Pacific Gas & Electric Company
ELC (Corp ID 39)
Status of Advice Letter 6403E
As of December 15, 2021

Subject: Request for Approval to Not Issue Competitive Solicitations for Distributed Energy Resource (DER) Procurement for Electric Distribution Deferral Opportunities

Advice 6403-E

Figure 2-1; Comparison of IEPR and Load Forecast Used for GNA

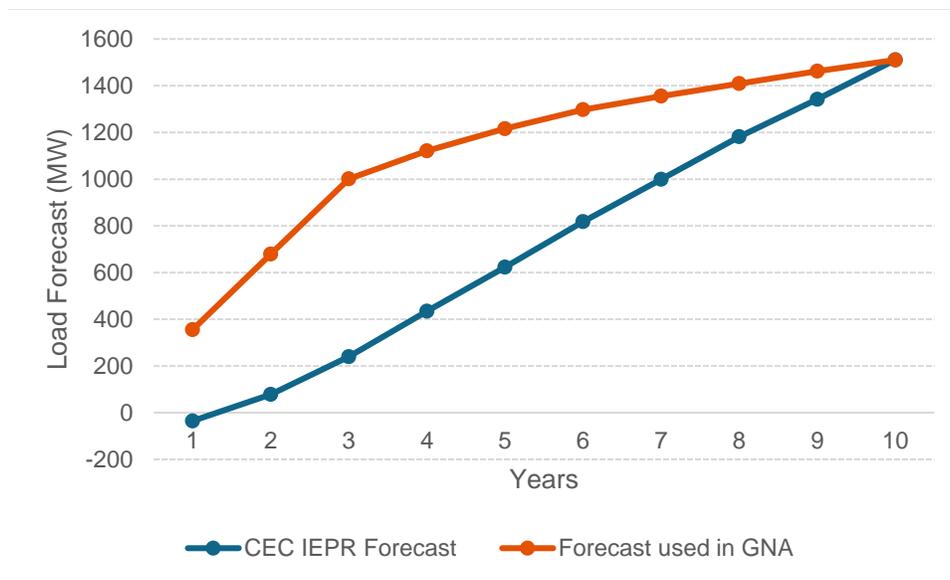
We can see in the Figure 2-1 below, the result of this approach to the application of known loads – the aggregate load growth in the PG&E forecast is higher than the IEPR aggregate load growth until year 10 when the values are the same. As seen in the Figure, the cumulative known load after three years is greater than the cumulative IEPR forecast for the same period by over 750 MW. Therefore, the load forecast used in the GNA for the first three years is substantially higher than the CEC IEPR forecast. Starting with year four, the GNA forecast and the IEPR aggregate forecast begin to converge and finally converge in year 10. This is a result of the limited number of applications and therefore new known loads in the later years. It is observed this approach will likely result in more investment in the earlier years than if the IEPR forecast was used without adjustments.

As mentioned in Section 2.3, the load forecast in the early years of the GNA is substantially higher than the IEPF forecast due to known new loads. The higher forecast in the first three years may pull the needs from later years into the years one through three which DERs are unable to defer due to the timing screen. Since these known loads in the first three years have a significant impact on planning and the DIDF process, the IPE recommends that PG&E gather data that will track how many of these known loads materialize each year. This information can then be used to adjust the known load additions in future cycles. We recommend the IPE review this data as part of its annual review.

Figure 7-17: Percent Difference Distribution

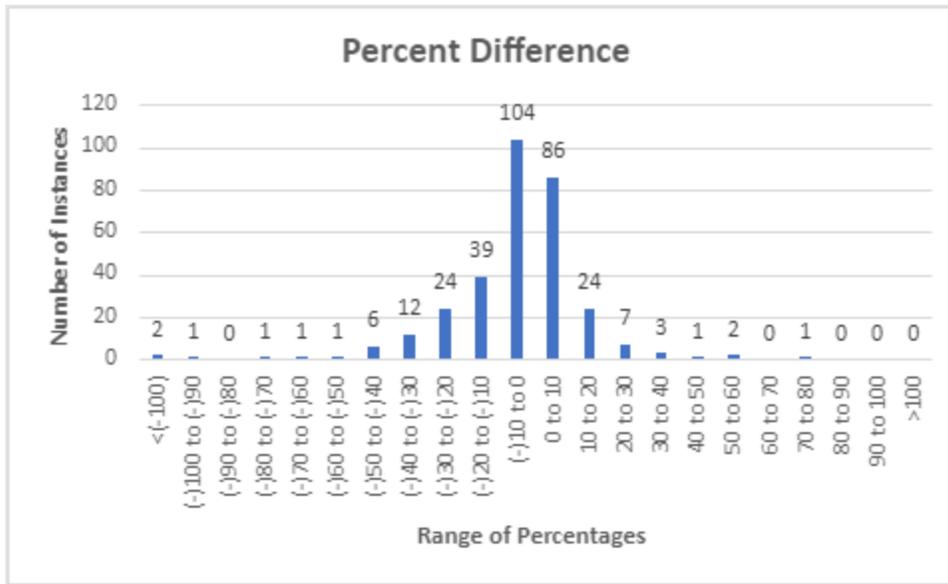
It can be inferred that the about 60% of the forecasted loads are within +/-10% of the actual values and about 80% of the forecasted loads are within +/-20% of the actual values.
